Item 5.**Development Application: 21C Billyard Avenue, Elizabeth Bay - D/2019/665**

File No.: D/2019/665

Summary Recommendation: This proposal is recommended for refusal.

Figure 12: South elevation of existing building and proposed addition showing setback from Onslow Avenue and additional height in storey

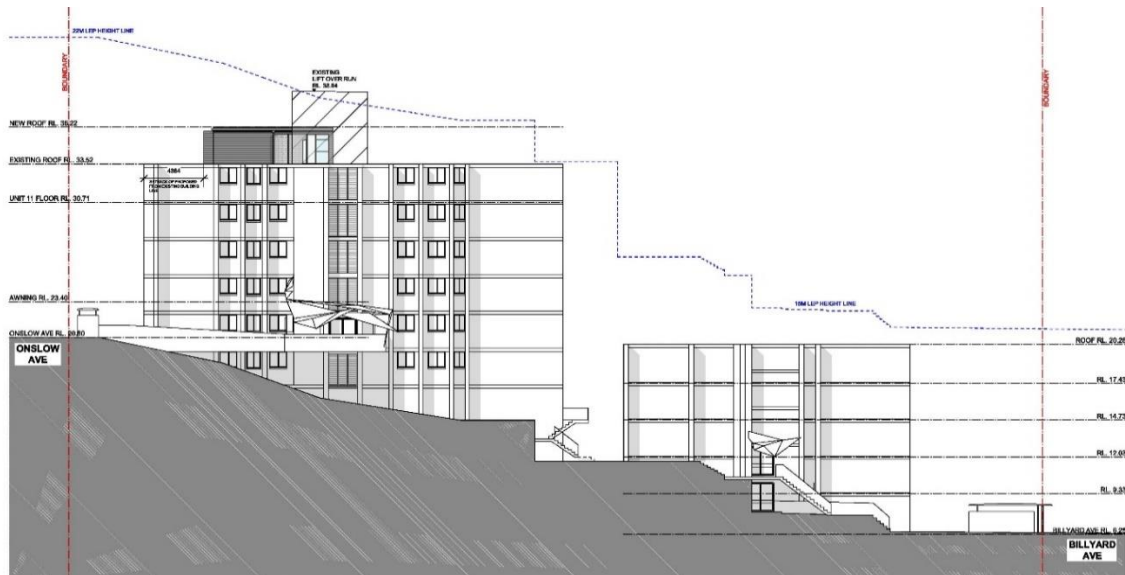
39. The proposal increases the building height in the middle of the building from six to seven storeys. This is acceptable from a streetscape point of view as the proposal will not be overly visible from Onslow Avenue or Billyard Avenue, and the increased height in this location is adjacent to the existing lift overrun (Figure 12).
40. As discussed above however, it is unclear whether this height in storeys non-compliance can be supported from view sharing or view corridor perspectives.

41. Following a review of the original proposal by the City's Heritage Specialist and Urban Designer, a number of concerns were raised with regard to materiality. The originally proposed materials, which included marble cladding, tile cladding and zinc, were out of character with the existing building, which is primarily constructed of brick and render. The application also lacked detail regarding materials, colours and finishes.

42. The application was amended to simplify the proposed material palette to better align with the materials of the existing building and surrounding conservation area, as well as provide additional details on proposed colours and finishes.

43. The revised proposal is acceptable. The refinement of materials combined with the considerable setback of the addition from Onslow Avenue results in a building that is not inconsistent with the streetscape and will not detract from the heritage conservation area.

Figure 14: North elevation of Darnley Hall showing additional overshadowing at 1:00pm on 21 June

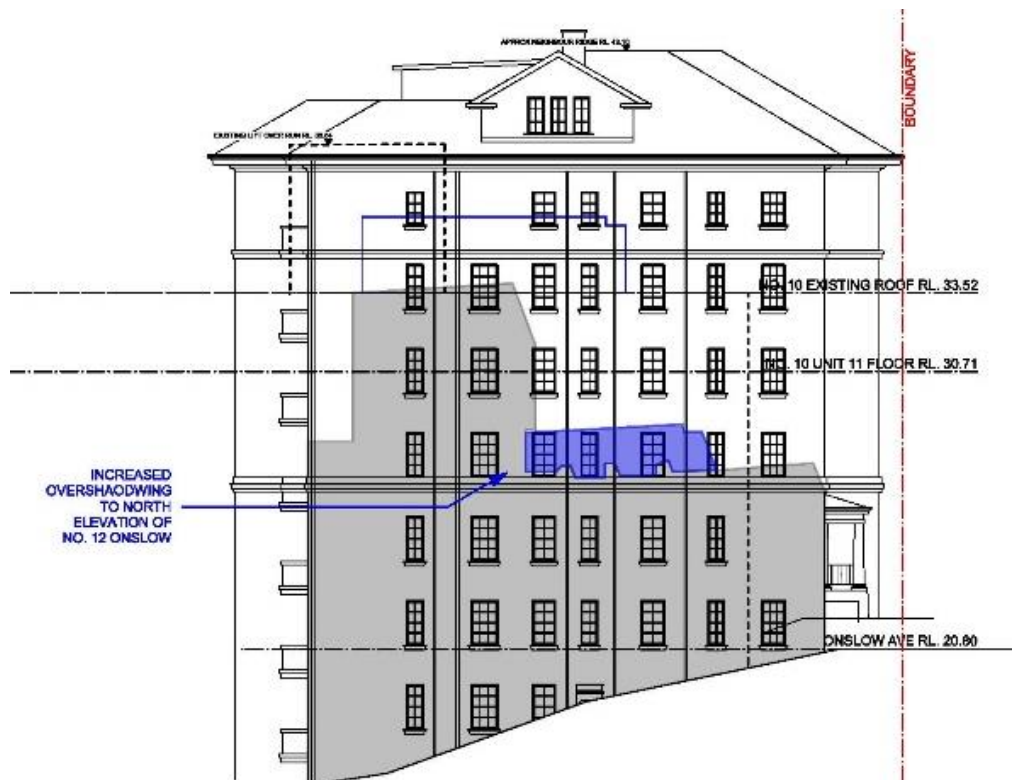
- Windows located along the northern elevation are to bedrooms, kitchens laundries and bathrooms.
 - The elevation shadow study shows that three windows will be impacted by additional overshadowing in the afternoon for one hour between 12.30pm and 1:30pm.

- The overshadowing of these windows is acceptable as these windows are not to living rooms and are therefore not protected from overshadowing under the DCP.

- Further, these windows still receive a minimum of 2 hours of direct sunlight to a significant portion of the window between 9am and 3pm on the 21 June.
